NOTICE OF VIOLATION

INSPECTION REPORT

Electrical Corporation:	Pacific Gas and Electric Company
Report Number:	CAD_PGE_BKA_20250116_1052
Inspector:	Babak Kaviani
WMP Year Inspected:	2024
Quarterly Data Report (QDR) Referenced:	Quarter 3 (Q3)
Inspection Selection:	Energy Safety viewed the contents of the Q3 QDR and performed an analysis that resulted in the selection of the WMP initiatives and locations referenced in this report.
Relevant WMP Initiative(s):	8.1.2.10.5 – Non-Exempt Expulsion Fuses
Date of inspection:	January 16, 2025
City and/or County of Inspection:	Jackson, Amador County
Inspection Purpose:	Assess the accuracy of PG&E’s QDR data, completeness of its work, compliance with WMP requirements, and compliance with its protocols.

Item1IA1Img1: Overall pole

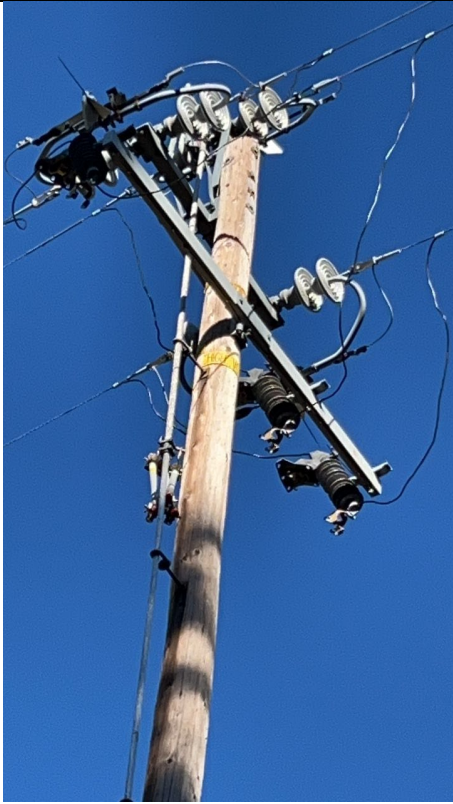
On pole ID 121607030, Grid Hardening ID 31658594 at 20411-20201 Ponderosa Way, Jackson, CA 95642, USA, 38.364894, -120.651515, the inspector observed that the CalFire-exempt fuses were not attached to the cutouts. The inspector's observation is documented in Violation 1 photographs, which are attachments to this report. Photo numbers Item1IA1Img1, Item1IA1Img2, Item1IA1Img3, Item1IA1Img4, Item1IA1Img5 depict incomplete installation of CalFire-exempt fuses. PG&E reported that work on WMP initiative 8.1.2.10.5 – Non-Exempt Expulsion Fuses was completed at this location.

1. The CalFire-exempt fuses were not attached to the cutouts.
